**SOLICITATION AMENDMENT
MODIFICATION DE L'INVITATION**

Title - Sujet Security System for Maritime Centre Système de sécurité pour le Centre Maritime	
Solicitation No. - N° de l'invitation H1121-214780/A	Amendment No. - N° modif. 001
Client Reference No. - N° de référence du client H1121-214780	Date 2022-09-07
GETS Reference No. - N° de référence de SEAG PW-\$\$HN-336-81347	
File No. - N° de dossier hn336.H1121-214780	CCC No./N° CCC - FMS No./N° VME
Solicitation Closes - L'invitation prend fin at - à 02:00 PM Eastern Daylight Saving Time EDT on - le 2022-09-27 Heure Avancée de l'Est HAE	
F.O.B. - F.A.B. Plant-Usine: <input type="checkbox"/> Destination: <input type="checkbox"/> Other-Autre: <input type="checkbox"/>	
Address Enquiries to: - Adresser toutes questions à: Bisson(hn336), Phillippe	Buyer Id - Id de l'acheteur hn336
Telephone No. - N° de téléphone (613) 295-8641 ()	FAX No. - N° de FAX () -
Destination - of Goods, Services, and Construction: Destination - des biens, services et construction:

SOLICITATION AMENDMENT 001 IS RAISED TO ANSWER THE FOLLOWING QUESTIONS AND MODIFY THE REQUEST FOR PROPOSAL, AS FOLLOWS:

18th FLOOR NORTH

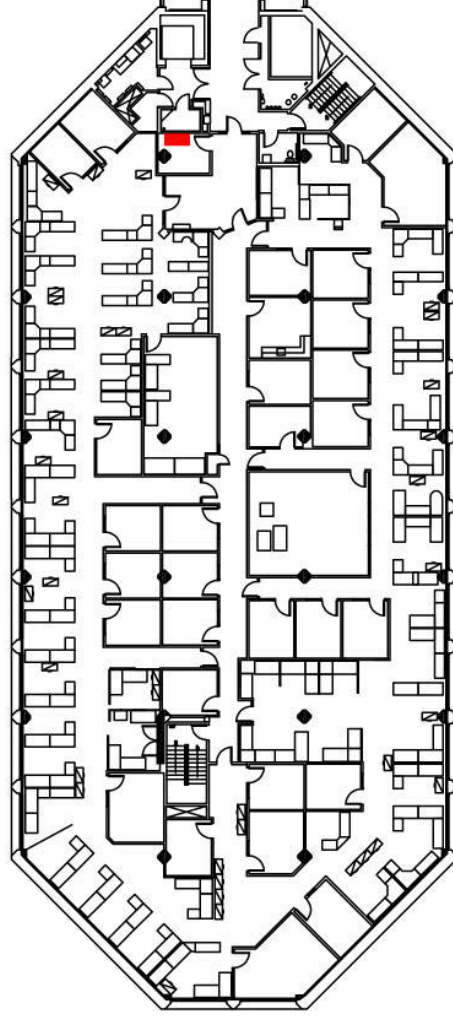
18th Floor North Drawing (available below)
